## Motorola Solutions Technical Notification (MTN)

**TITLE:** APX/PCR RSM Cable Jacket separation/fraying exposing internal wires

**TECHNOLOGY:** Accessory - APX/PCR Remote Speaker Microphones

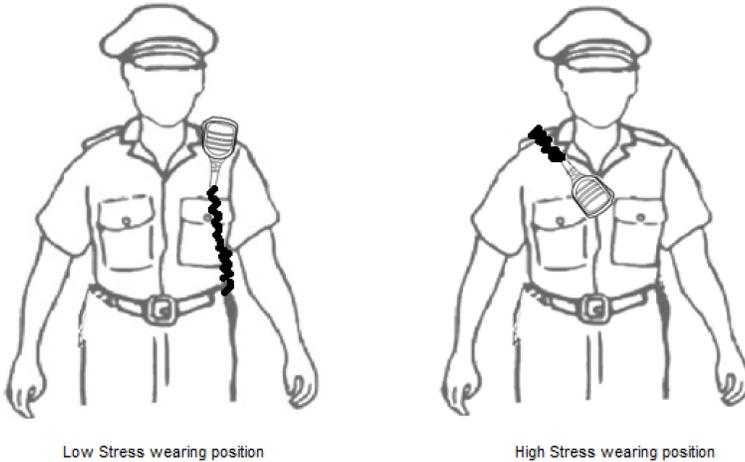
The RSM cable jacket tears or frays and exposes the internal wires. See the example picture below..

Cable tear or fray is a condition in which:

- the RSM cable black outer jacket develops frays that get worse with use
- the inner cable contents become visible
- typically occurs at RSM head or radio connector (GCAI) end or both, but can also occur in cable middle section.

Susceptibility to the cable jacket tear phenomenon has been significantly reduced by increasing the coil diameter which effectively reduces coil cord stress. Motorola strongly recommends RSM users to dress the RSM coil section of the cord in such a way that it does not get caught on uniform accessories and equipment or equipment worn on the person for optimal RSM service life.

The following lists show which model RSM is to be used for replacement with the larger coil diameter solution.
